Subject: AP1000 COL Standard Technical Report Submittal of APP-GW-GLN-079, (TR 79),
Revision 0

“Electrical System Design Changes”

Technical Report 79

TITLE: **Electrical System Design Changes**

Figure 2.6.1-1 (Sheet 3 of 4)
Main ac Power System

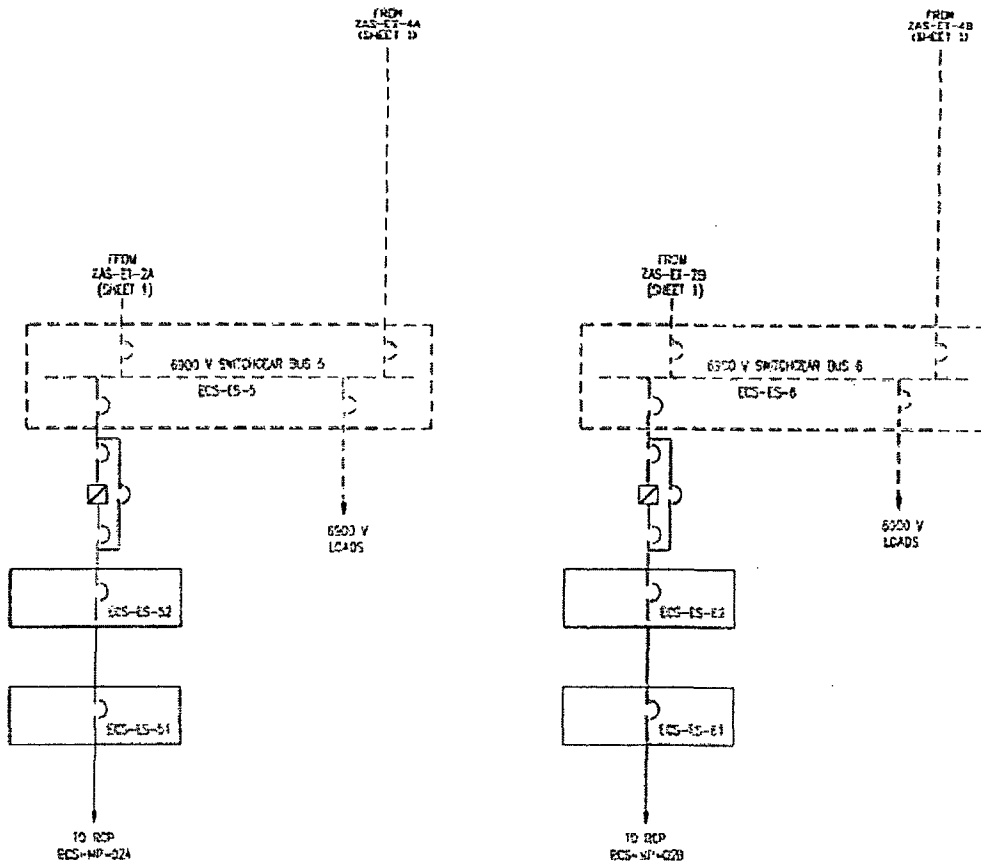
The addition of a fast bus transfer, along with an operator initiated maintenance transfer was made to the AP1000. This change required an additional Reserve Auxiliary Transformer (RAT) to allow complete bus transfer from Unit Auxiliary Transformers to Reserve Auxiliary Transformers. DCD figures 8.3.1-1 and 2.6.1-1 will be revised along with several portions of the DCD text.

Figure 8.3.1-3

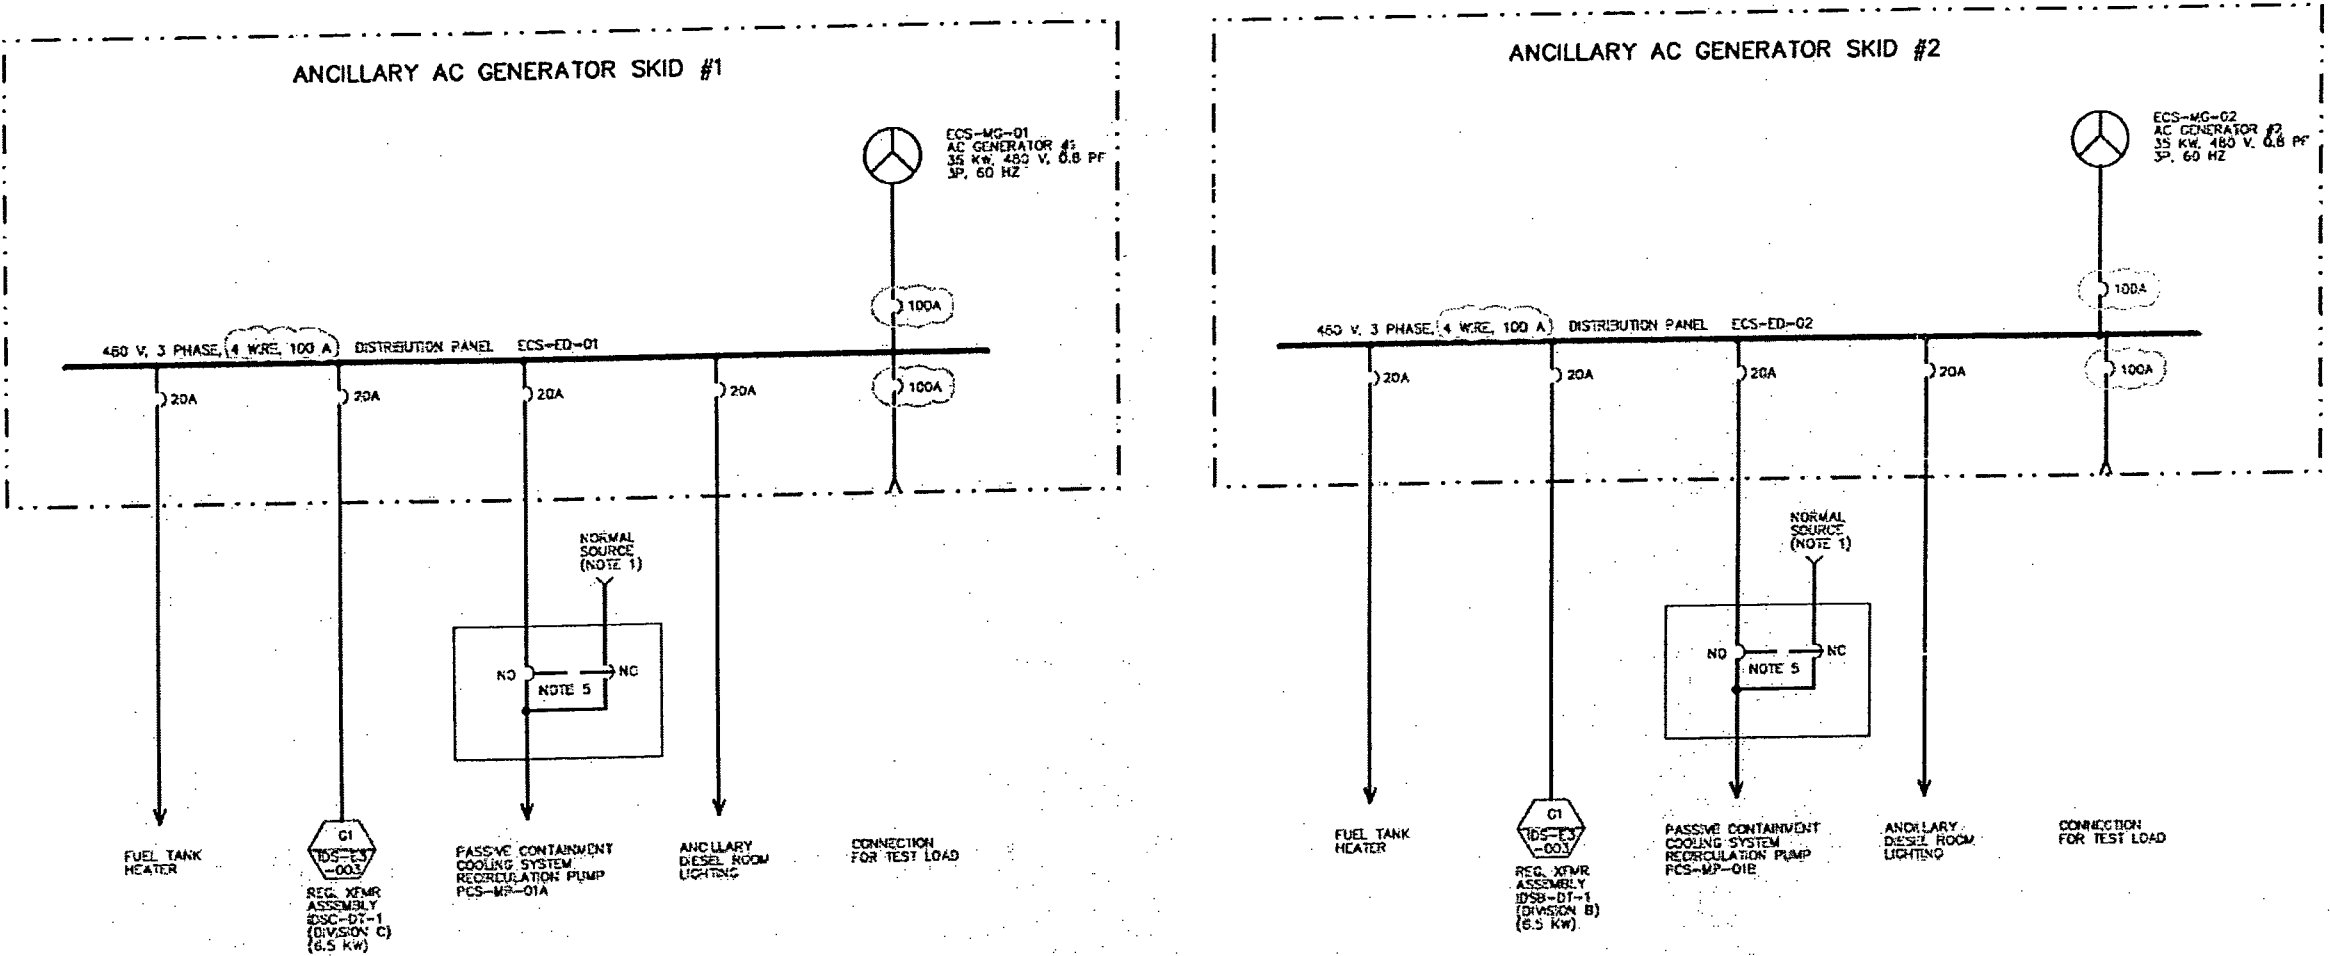
Item: Ancillary diesel 1-line Figure 8.3.1-3 was revised to reflect a 4 wire 100A distribution panel (from a 3-wire 50A), and a 100A breaker for both the diesel generator to the bus and for the test load tie to the bus from 50A (page 8.3-56).

The size of the ancillary diesel generator distribution panels are shown as 50A with an incoming breaker of 30A from the generator. Full load current of this generator is approximately 53A. The main breaker of the distribution panel should be sized at the full capacity of the generator at a minimum. The diesel generator test load will also be changed to 100A to allow for this generator to be tested at full capacity. Additionally, to facilitate the use of this source as a feed to 277Vac lighting circuits, these panels will be changed from 3W to 4W.

A review of industry standard product offering for 480Vac distribution panels shows that the minimum sized standard product is a 100A main breaker, 100A main bus. The rating of these panels will be changed to reflect this 100A rating based on the ready availability of standard product offerings.

Item: Ancillary diesel 1-line Figure 8.3.1-3 was revised to reflect a 4 wire 100A distribution panel (from a 3-wire SOA), and a 100A breaker for both the diesel generator to the bus and for the test load tie to the bus from SO (page 2.3-56).

Figure 8.3.1-3 of Revision 15 was revised to reflect a 4 wire 100A distribution panel, and a 100A breaker for both the diesel generator to the bus and for the test load tie to the bus.
